The following are the clarifications to the Plan Review Responses sent August 23, 2011. Revisions or clarifications have been identified with this written response.

Re:	PC #:	B1103915
	Commercial Plan Review Dated:	8.17.11
	Project Name:	Chase – CPC Alton
	Address:	1801 Alton Road
	Occupancy:	B

JPM Chase - Alton Road

CPC Interior Renovations

ELEVATION AT FRONT OF TELLER LINE SCALE 1/4" = 1'-0" 1

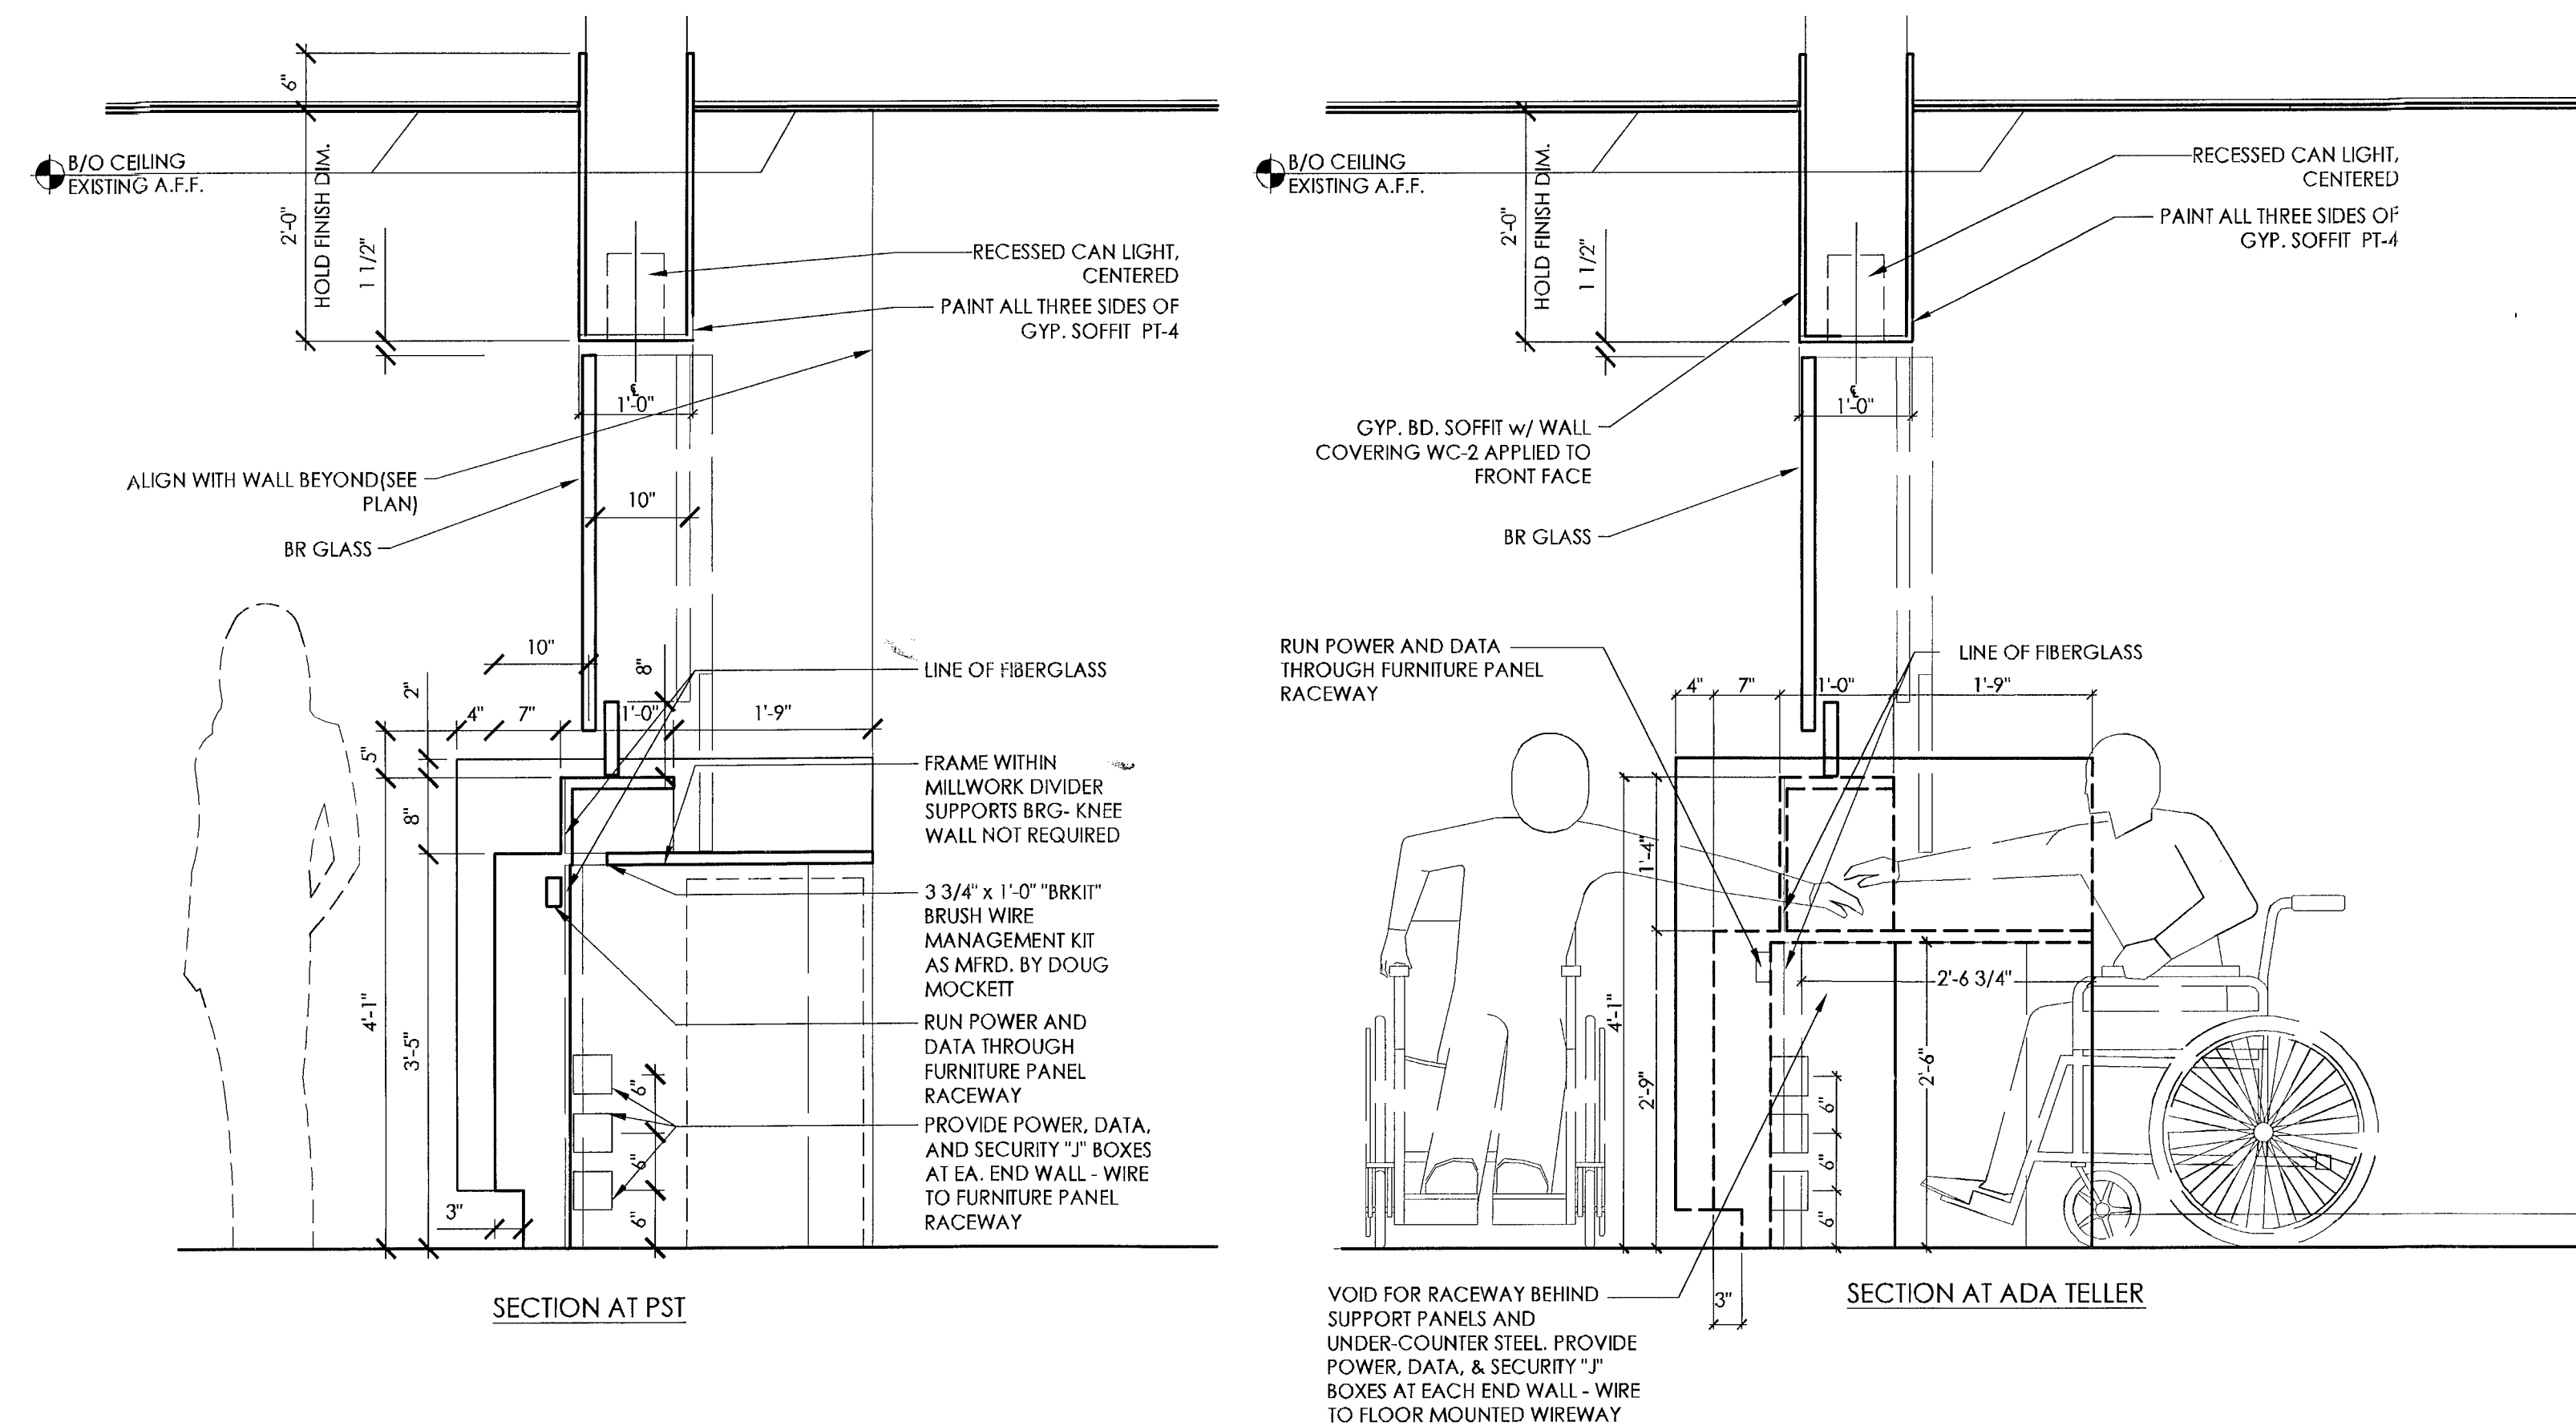
8. **Elevation 1/A5.1: Provide accessibility sign to comply with FAC §216.**

9. **Elevation 1/A5.1: Provide length of accessible teller counter, 36" minimum, to comply with FAC §904.4.**

RESPONSE: Please refer to attached revised sheet A5.1, detail 1, for requested detail.

RESPONSE: Please refer to attached revised sheet A1.2, detail 2 for requested information.

SECTIONS AT TELLER LINE SCALE 3/4" = 1'-0" 5

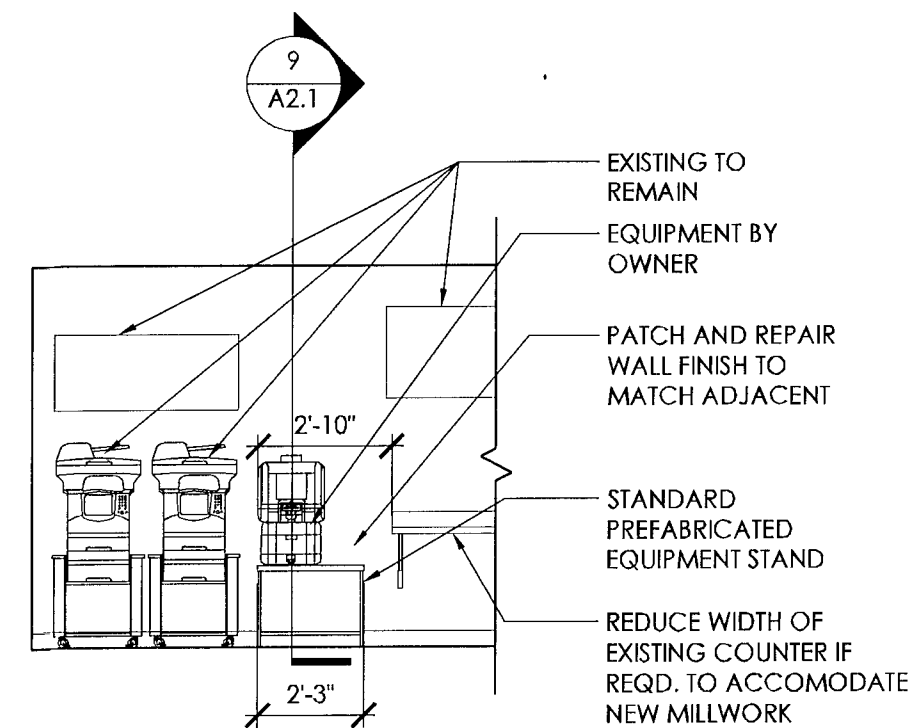
10. **Section 5/A5.1: Provide bottom of counter knee clearance dimension, 27" minimum, per FAC §306.3.**

11. Section 5/A5.1: Provide 25" maximum reach dimension, suggest reduce 1'-9" dimension to 1'-1" to comply with FAC §308.2.

RESPONSE: Please refer to attached revised sheet A5.1, detail 5, for requested information.

SCHEMATIC CEILING SECTION SCALE 1/2" = 1'-0" 8

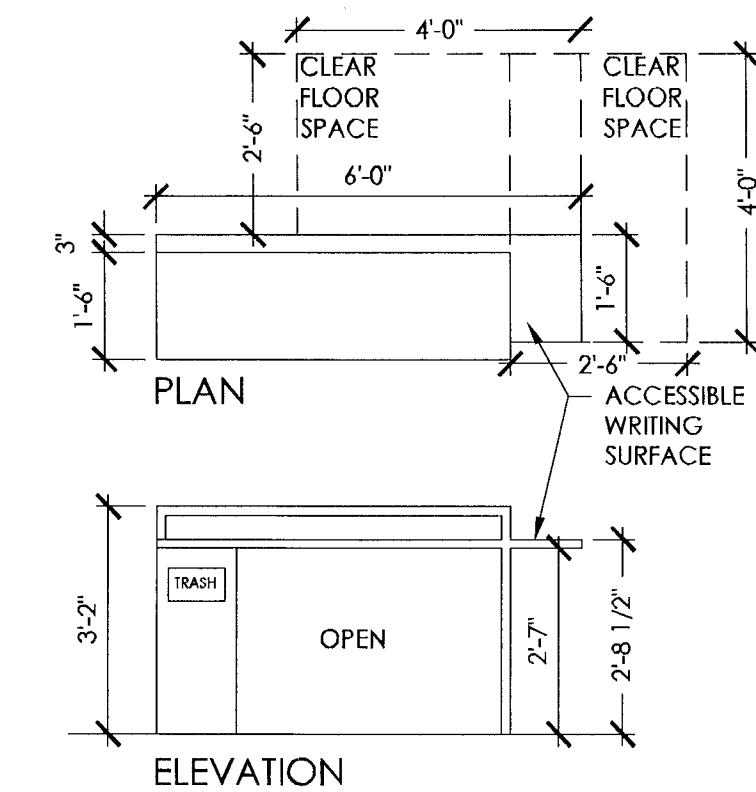
2. **Sheet A0.0: Provide number of stories of building. Clarify if floor ceiling assembly over work area is a fire rated separation for occupancy above. If so, on plans provide a cross section and a UL detail (or equal) for the fire rated floor-ceiling assembly in compliance with FBC chapter 7.**

RESPONSE: The existing building has two stories. As per telephone discussion between Mr. Schaad (City of Miami Beach) and Caleb Janus (BDG Architects) on March 25, 2013, on-site investigations have been made, which indicate that the construction of the floor/ceiling assembly is poured concrete slab on poured concrete beams. As discussed, it is not possible to determine the exact nature of the materials and thickness of the structure. However, the existing floor / ceiling assembly is not being altered or affected in any way by the proposed renovation. Please refer to attached revised sheets A0.0 & A5.1 detail 8, for a schematic section of the existing condition as requested.

EXISTING CHECK DESK SCALE 3/8" = 1'-0" 9

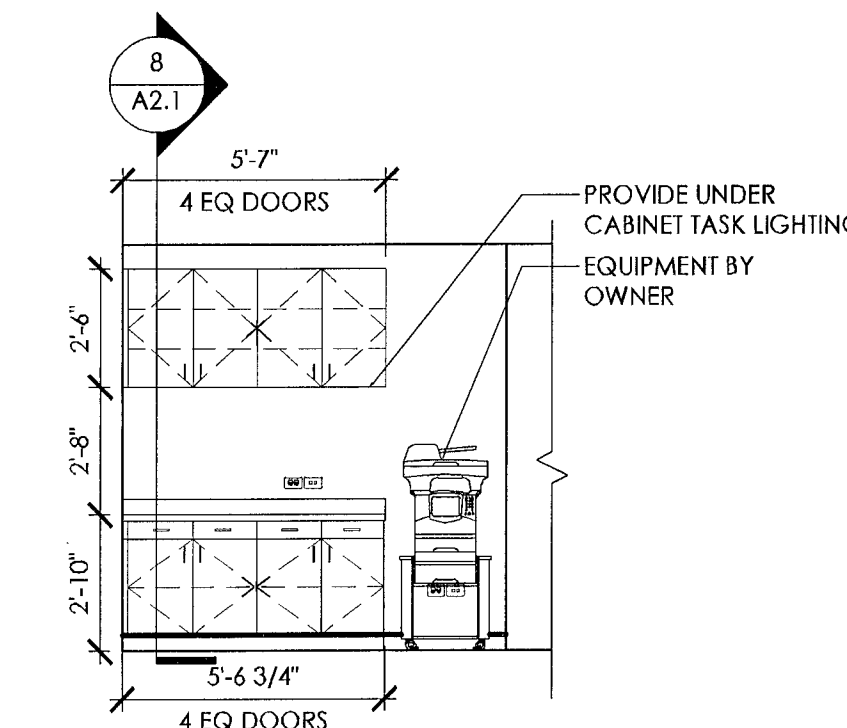
7. **Plan 2/A1.2: Check desk FP09: Provide check writing desk accessible details to comply with FAC §904.3.3.**

RESPONSE: Please refer to attached revised sheet A5.1, detail 9, for accessibility assessment of existing check desk to be relocated.
